APPLICATION NO.	FILING DATE	FIRST NAMED INVENTOR	ATTORNEY DOCKET NO.	CONFIRMATION NO.
10/564,955	01/18/2006	Tomoyasu Terada	050854	4103
23850	7590	02/22/2007	EXAMINER	
ARMSTRONG, KRATZ, QUINTOS, HANSON & BROOKS, LLP			LEE, JINHEE J	
1725 K STREET, NW			ART UNIT	PAPER NUMBER
SUITE 1000				
WASHINGTON, DC 20006			2174	
SHORTENED STATUTORY PERIOD OF RESPONSE		MAIL DATE	DELIVERY MODE	
3 MONTHS		02/22/2007	PAPER

Office Action Summary	Application No.	Applicant(s)	
	10/564,955	TERADA, TOMOYASU

DETAILED ACTION

【図6】

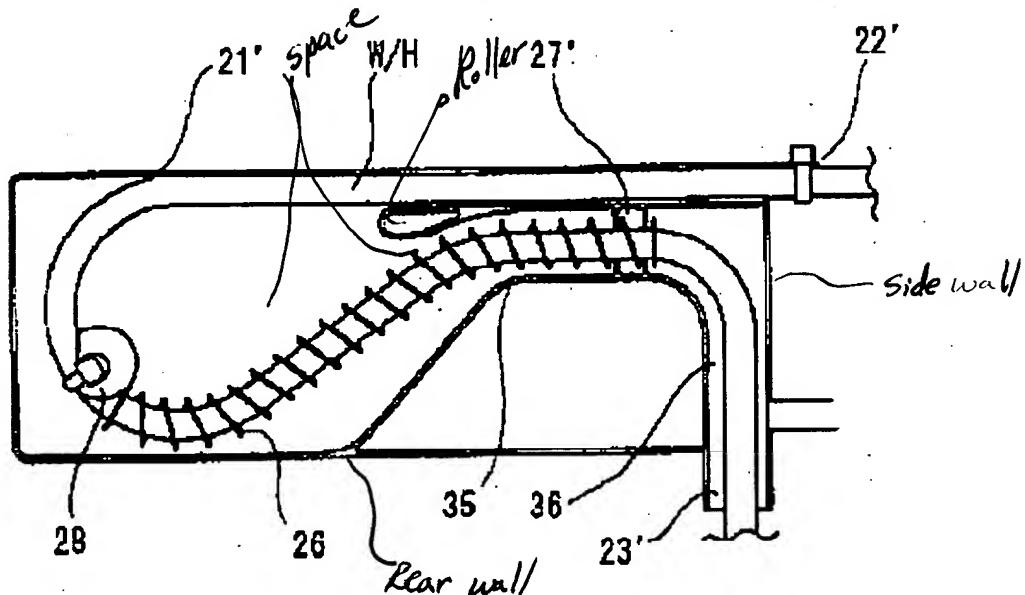
a case (21) having a base wall, front wall, rear wall, pair of side walls and a cover for receiving a wire harness having an inlet formed in a side wall adjacent the rear wall, and an outlet formed in the rear wall for the wire harness (see annotated figure 6 below), said inlet being perpendicular to the outlet;

an urging member (26 for example) for urging the wire harness toward an inside of the case; and

a harness roller (unnumbered see annotation for example) around which the wire harness being rolled, said harness roller reciprocally moving under acting forth of the urging member,

wherein a space for receiving a folded part of the wiring harness, formed by forming an overlap and then bending the wiring harness 90 degrees, is provided between the case and the urging member (see figure 6 for example);

wherein the folded part of the wiring harness is led into the case through the inlet and received in the space (see figure 6 for example).

Re claim 2, Kawamura et al. discloses device, wherein a center axis of the urging member is displaced from a center plane of said harness roller in a direction of

thickness of the device for providing a large said space for receiving the folded part of the wiring harness (see figure 6 for example). Or alternatively, the device of Kawamura et al. discloses the claimed invention except wherein a center axis of the urging member is displaced from a center plane of said harness roller in a direction of thickness of the device for providing a large said space for receiving the folded part of the wiring harness. It would have been an obvious matter of design choice to use a center axis of the urging member displaced from a center plane of said harness roller in a direction of thickness of the device for providing a large said space for receiving the folded part of the wiring harness in order to receive a folded part, since such a modification would have involved a mere change in configuration. A change in shape or configuration is generally recognized as being within the level of ordinary skill in the art. *In re Daily*, 149 USPQ 47 (CCPA 1976).
